Evaluation of Rollins Environmental Services (TX), Inc. Deer Park, Texas

UPDATE OF THE HAZARDOUS WASTE GROUND-WATER TASK FORCE EVALUATION OF ROLLINS ENVIRONMENTAL SERVICES (TX) DEER PARK FACILITY

EPA-330/2-86-010

GROUND-WATER MONITORING EVALUATION

Figure 6

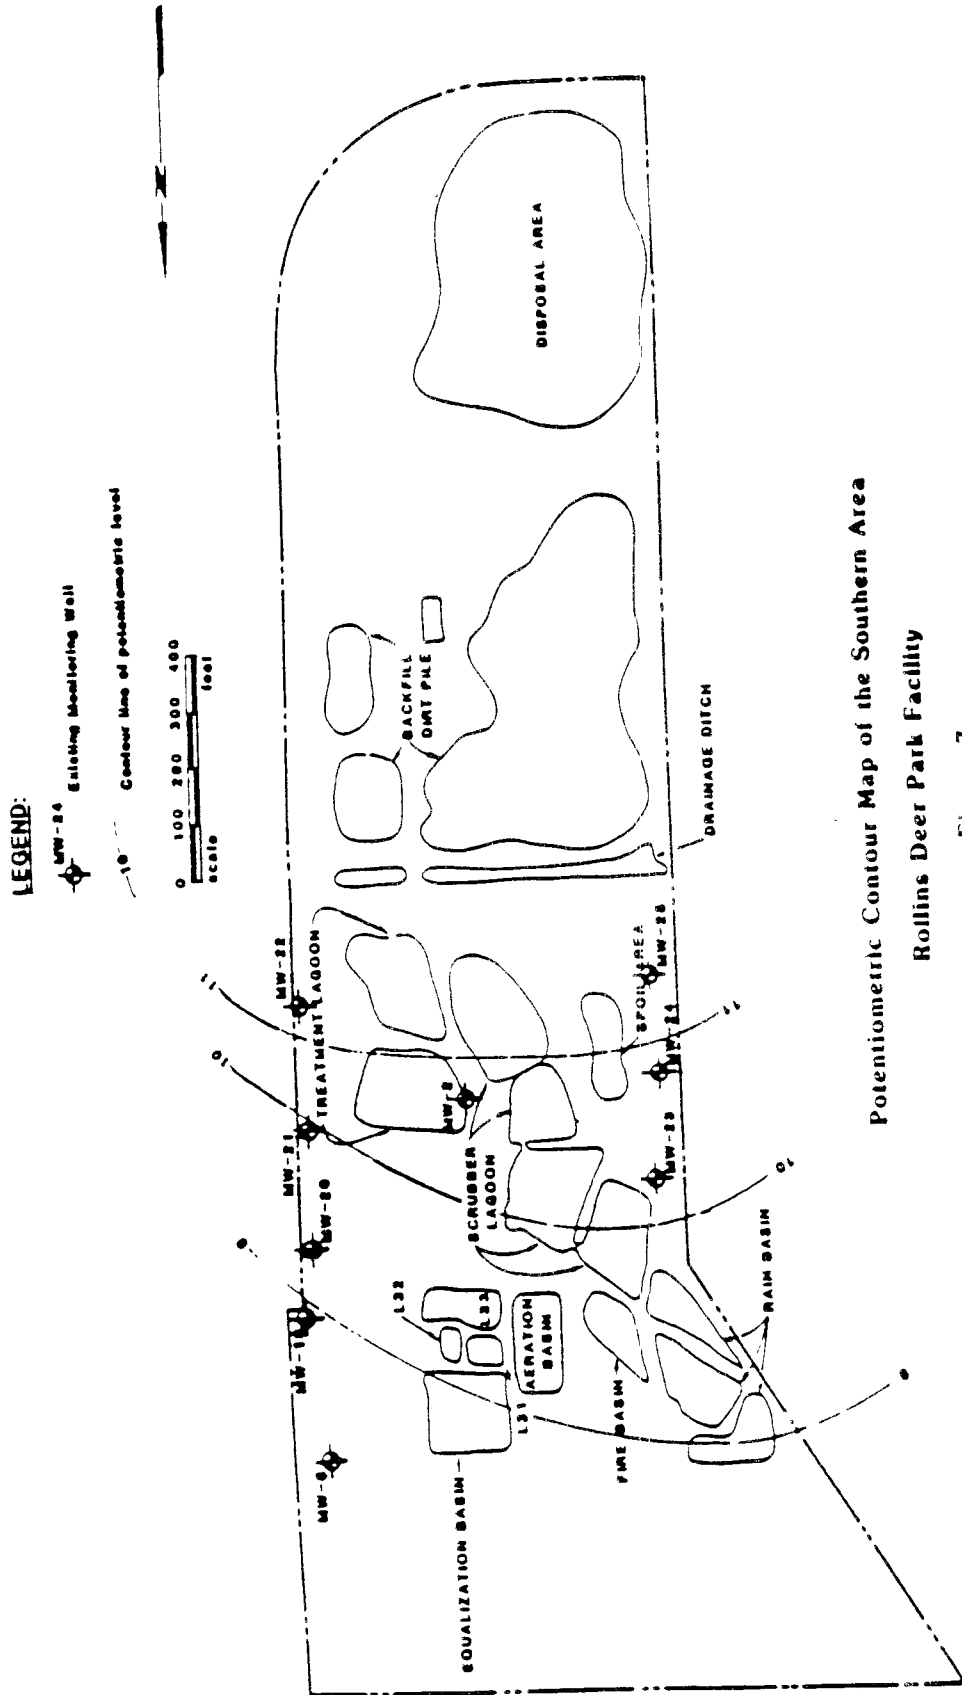
The potentiometric contour map for Stratum 3 in the southern portion of the site [Figure 6] suggests that horizontal ground-water flow is radially toward the active below-grade disposal area. This localized ground-water depression or sink is the result of pumping runoff and ground-water seepage ponded in the excavated area to dewater the active disposal cell.

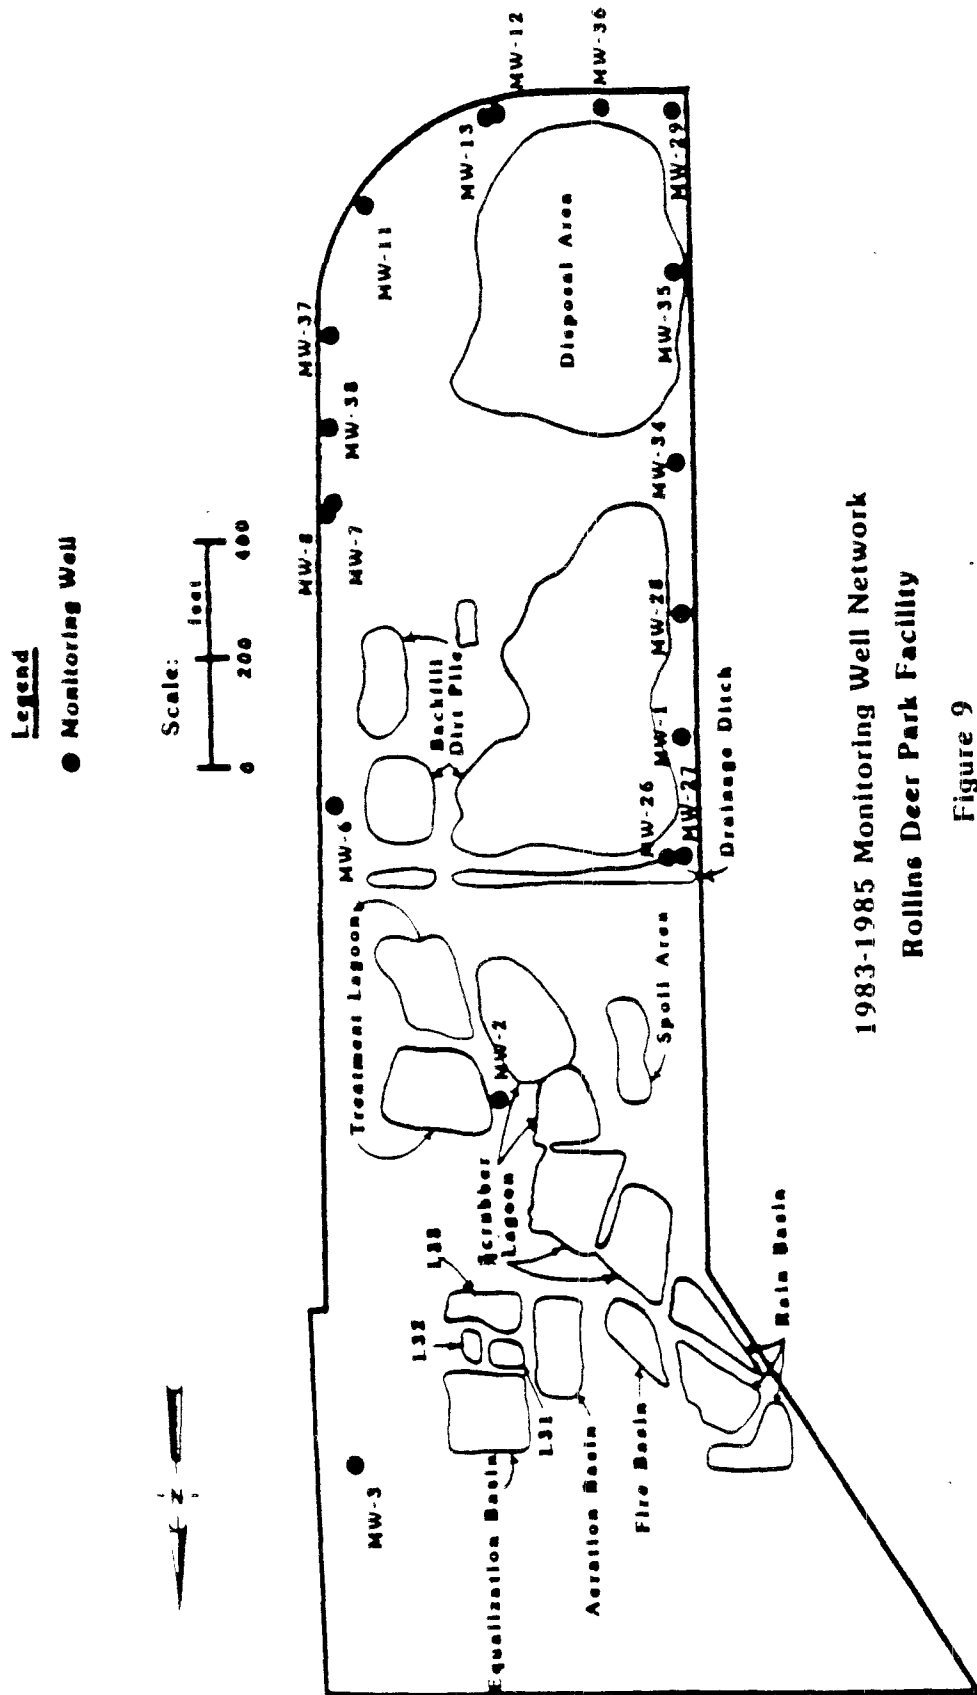
Given the northerly ground-water flow beneath the facility, there are no monitoring wells downgradient from most of the surface impoundments [Figure 8] in the northern part of the facility. The two designated down-gradient wells in that area (MW-2 and 3) are inadequately constructed, as previously described.

Figure 11

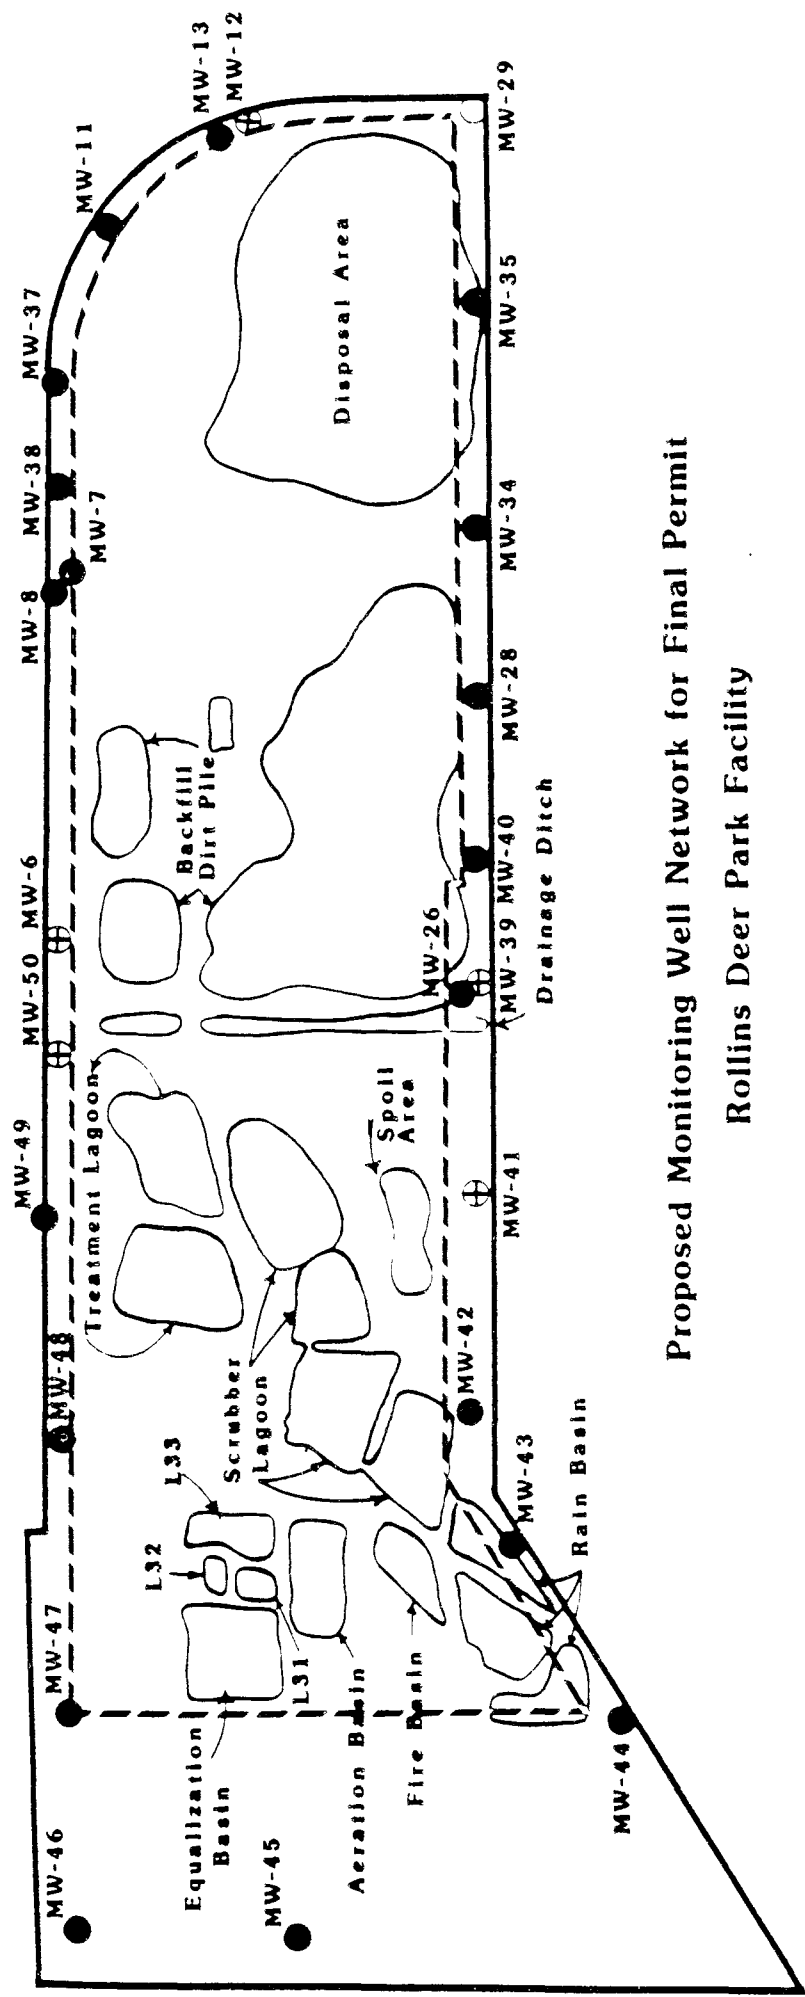
through the locations of proposed monitoring wells [Figure 11], which is essentially the site boundary.

The plan proposes a 25-well network around the waste management area which will ultimately consist of one large landfill. Because of the subsurface hydrology of the site, the well network is subdivided into northern and southern sections, each having a respective set of upgradient and downgradient wells. In the southern section, dewatering of the landfill excavation created a ground-water sink in the southern half of the site, thereby creating a different flow regime than in the unaffected northern half [Figures 6 and 7]. Task Force personnel concur with the sectioning of the waste management area delineations.

The 25-well network will comprise 13 from the existing network and 12 installed as replacements for older ones. The description of abandonment procedures for the wells being replaced is incomplete. More detail is necessary on how the casing and sand pack would be removed. Specifications for the bentonite/grout mixture used to backfill the hole and details of emplacement are necessary in order to evaluate the adequacy of the proposal.

Construction details for the replacement wells are also incomplete. Mud rotary is an acceptable method; however, water should be tried as the initial fluid and mud added only if necessary. Also, the type of mud and any additives used should be specified. The method and rationale for selecting the screen slot and sand pack sizes needs to be stated in the text. Details on how the casing, sand pack and grout will be implaced need to be included. The use of PVC casing is not recommended by the Task Force because of absorption/desorption problems with some hazardous waste constituents.

Four of the "downgradient" wells (MW-46 through 49) may not be downgradient from the waste management area. The water-table contour map of the northern area (Figure 4 in the plan) has no reliable data points between the eastern and western boundaries to suggest northeasterly flow toward the four wells. The monitoring plan should use past water level elevation data to indicate whether there are seasonal variations in flow directions and illustrate interpretations on maps.
